Memorandum

Date: October 20, 2021

Re: Hudson Valley Shakespeare Festival (HVSF) Project

COMMENTS ON APPLICANT'S OCTOBER 7, 2021 SUBMISSION

PLAN SET
 PREPARED FOR
 GARRISON PROPERTIES, LLC
 &
 HUDSON VALLEY
 SHAKESPEARE FESTIVAL, INC
 VEHICLE MOVEMENTS

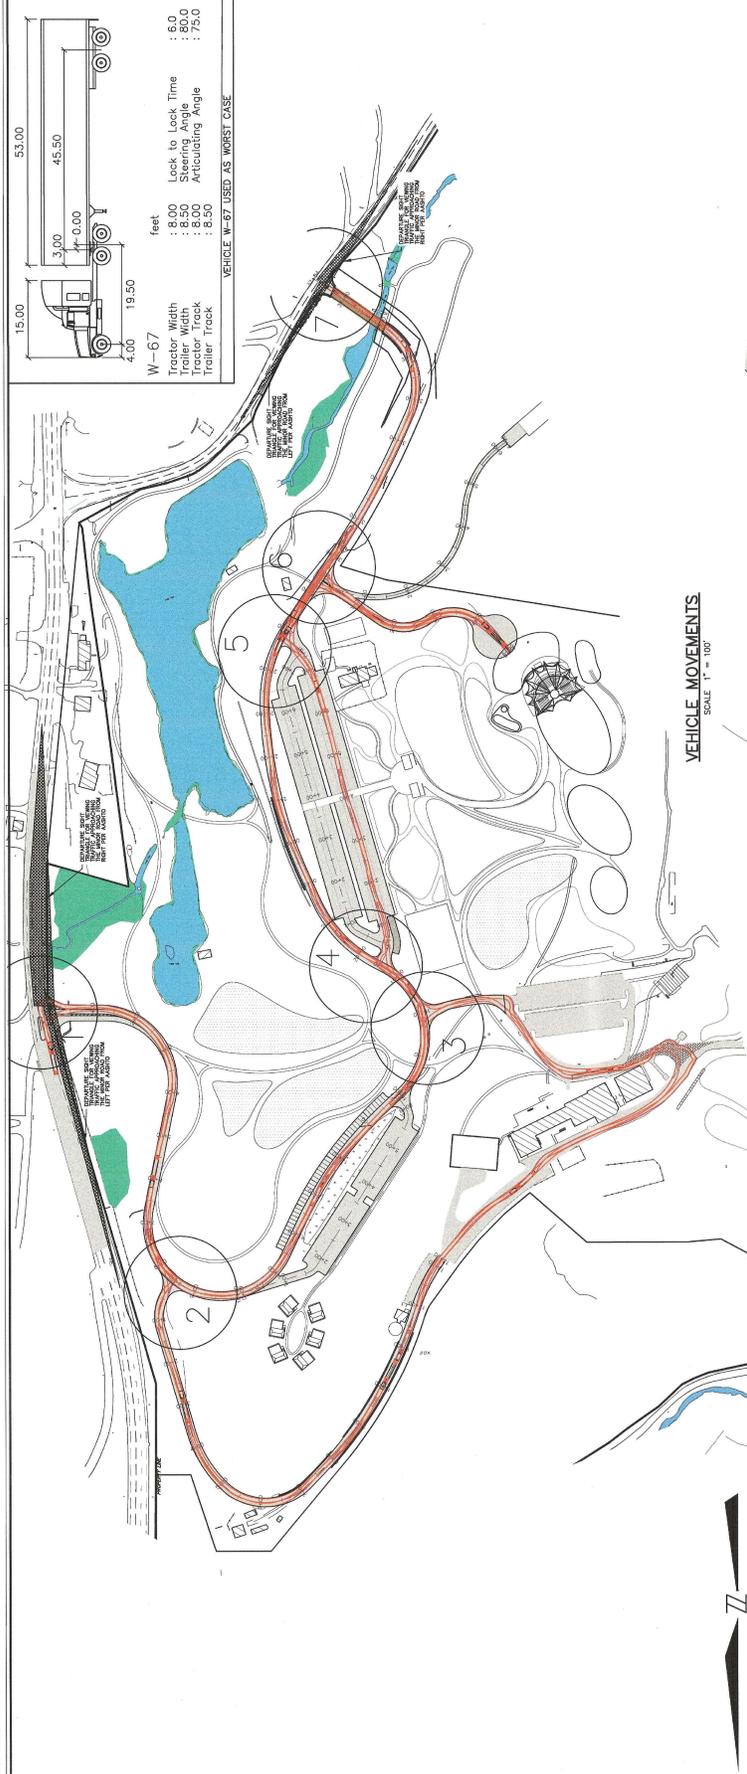
The revisions made to the TIS partially address this comment. The turning maneuvers at Location 7 from the driveway onto Snake Hill Road (see attachment, highlighted in red) are incomplete and need to be shown.

The revisions made to the TIS partially address this comment. If the referenced area is the area marked as "Departure Sight Triangle" on Sheet 9 of 9 of the Site Development Plans, "Vehicle Movements", it should be clearly labeled as "Area of Vegetation Removal Required."

REFER TO COMMENT #49
